Re: Light Rail – Lilyfield to Dulwich Hill Extension - Application reference number: MP 10_0111

RE: Sydney Light Rail – Inner West Extension Study

This letter by Friends of the GreenWay (Friends) Inc. is in response to the NSW Government's public exhibition of the Sydney Light Rail Extension - Stage 1 - Inner West Extension Environmental Assessment

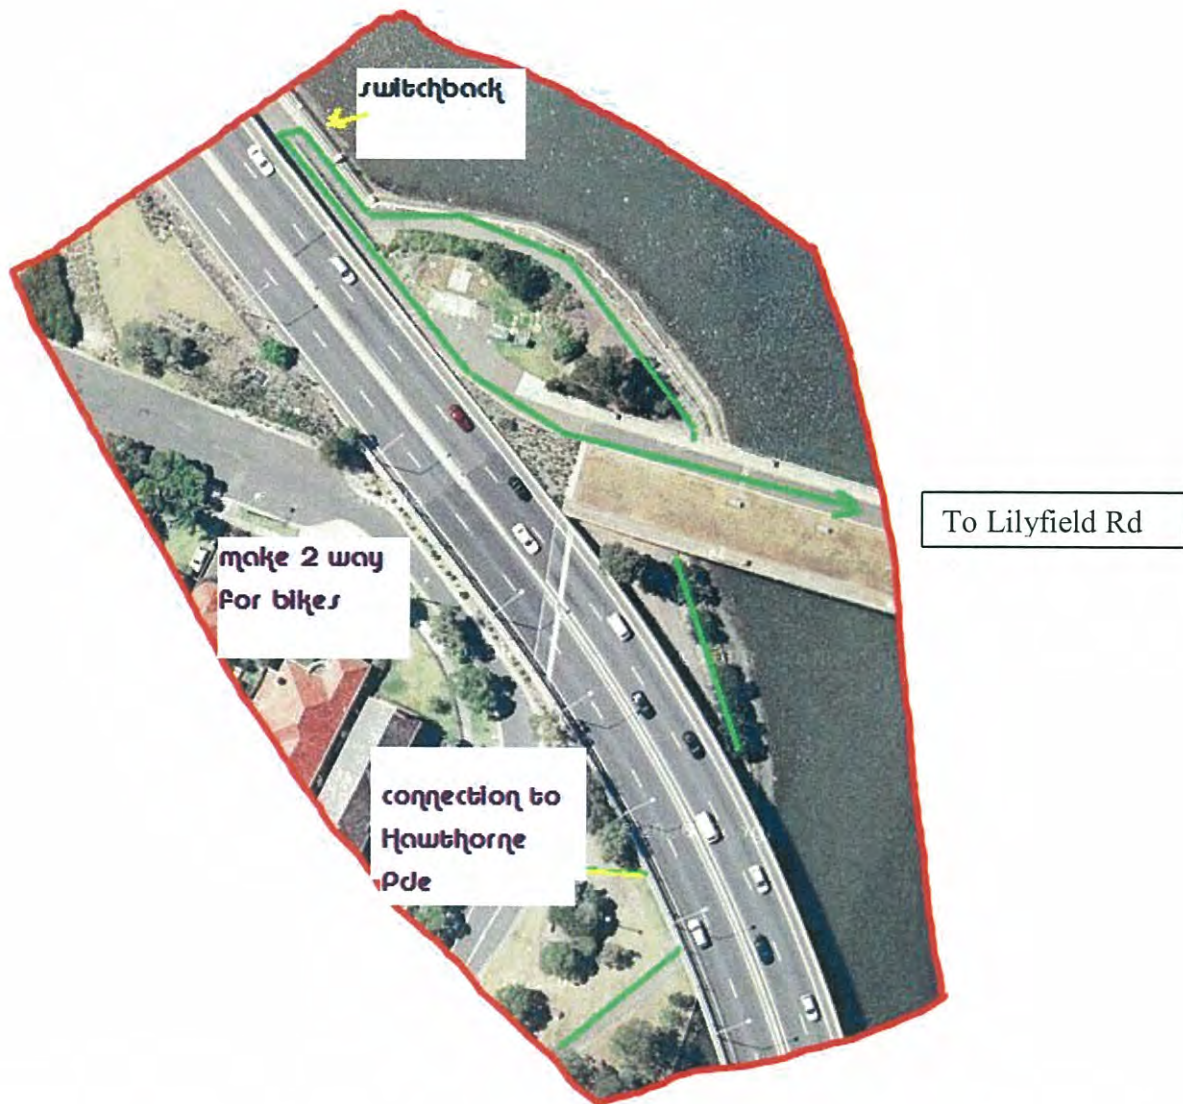
The curb extensions mentioned in the EA at the proposed Lyall St crossing should be designed to allow these bicycle lanes.

(b) Lyall St road closure structure should be modified to make it accessible for bicycles, and that the crossing of Darley Rd should be bicycle friendly,

note: Lyall St may become the favoured access route into Leichhardt over the steep Allen St, and Allen St is a proposed Regional Route in the Inner City Regional Bicycle Network plan.

Locations of stops

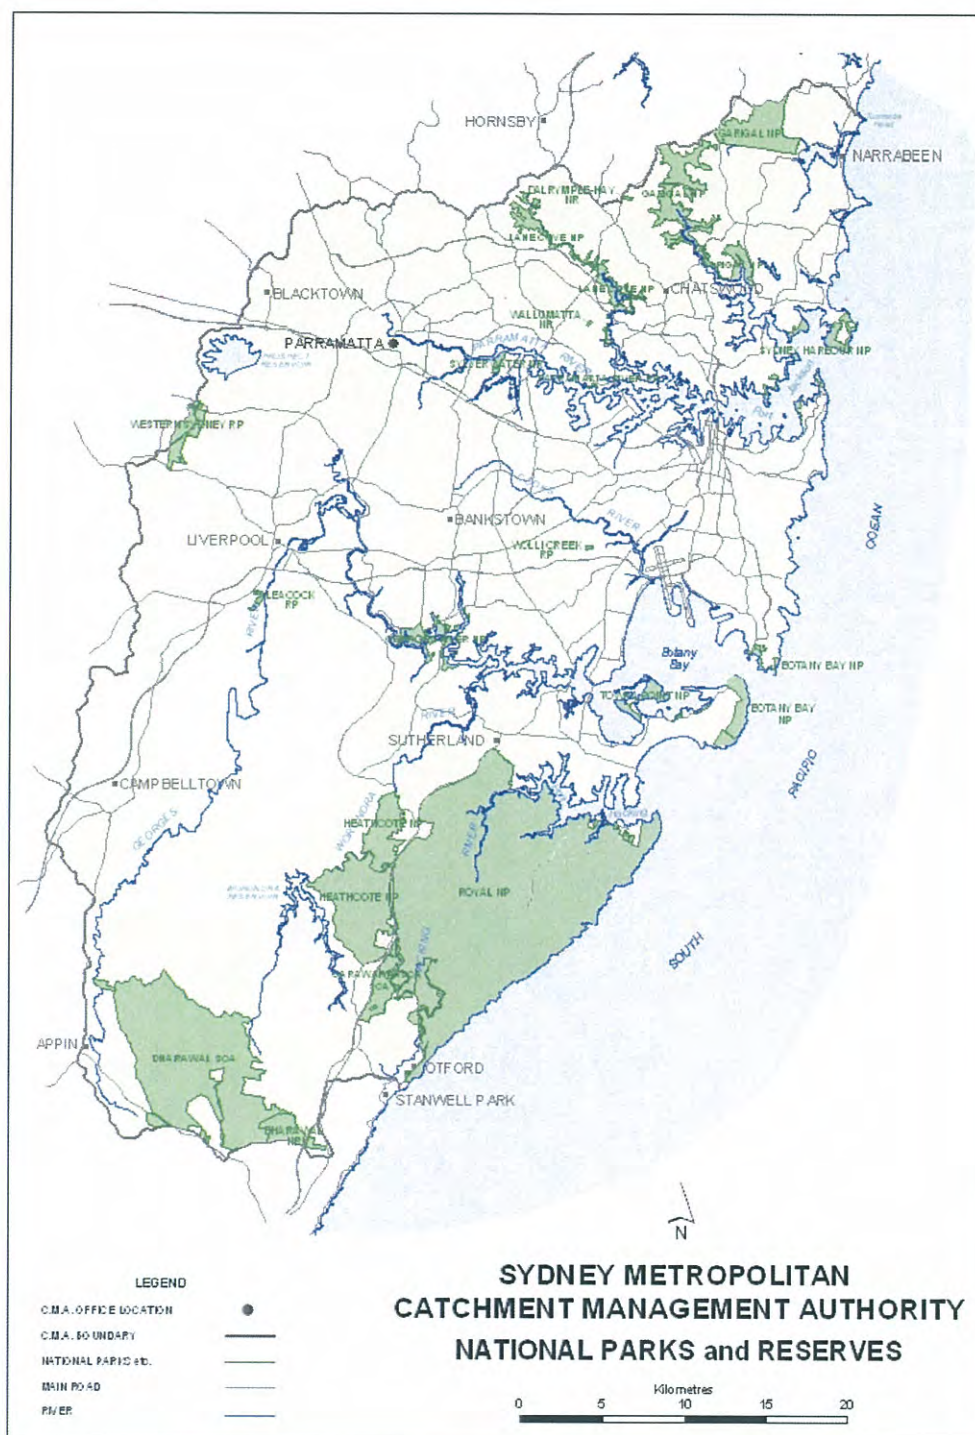
Lewisham West would be better placed near Longport Street. Access could be obtained from the southern side of Longport Street.

Dulwich Hill would be better placed on the goods line just before Wardell Road, with a lift to street level. The lift would be expensive but if a job's worth doing at all it's worth doing well.
